ADDENDUM NO. 2

CAMDEN AVENUE LIFT STATION REPLACEMENT

CITY OF CAMDENTON

Date: Tuesday, June 20, 2023

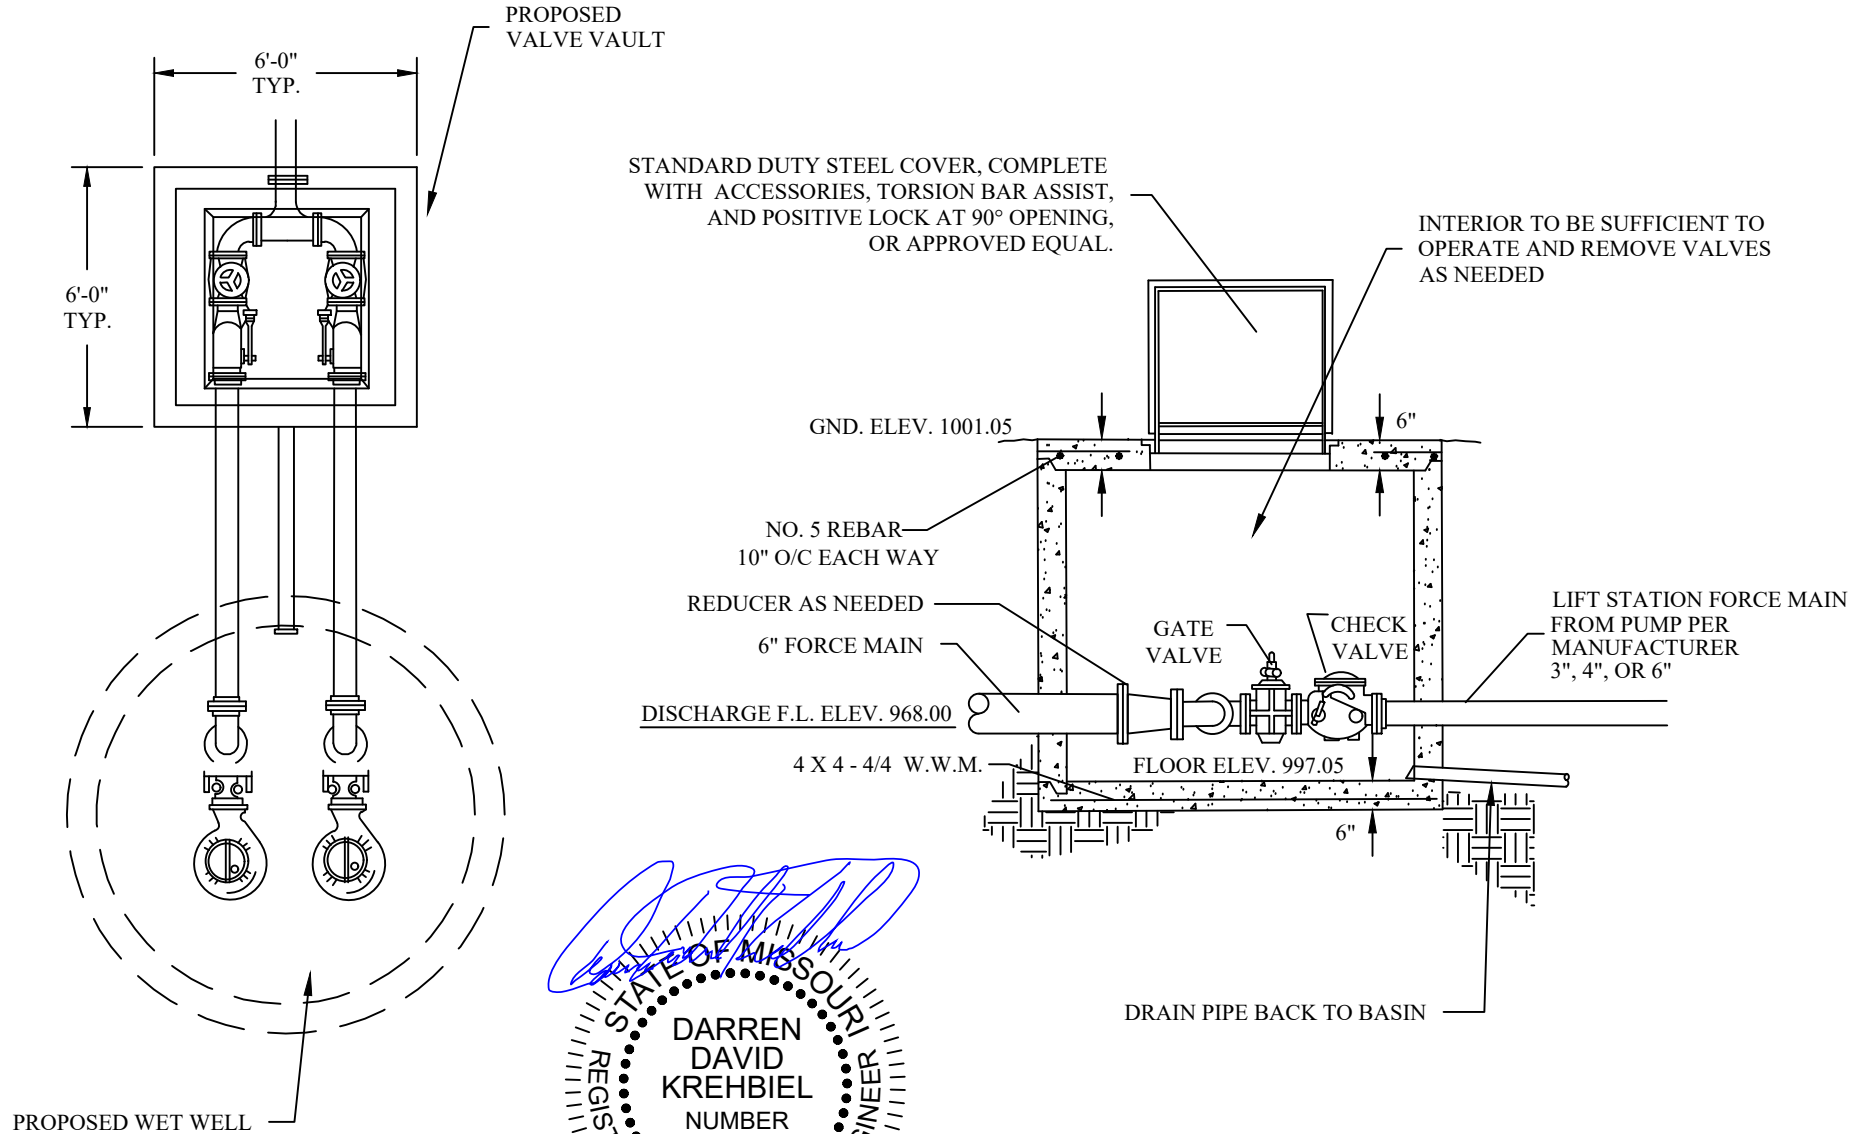
To address the requirement for stainless steel, check valves and shut off valves can be installed outside the vault. A typical valve pit detail is attached.

NOTE: VALVE VAULT MAY BE SQUARE OR ROUND, CONCRETE OR PRE-MANUFACTURED.
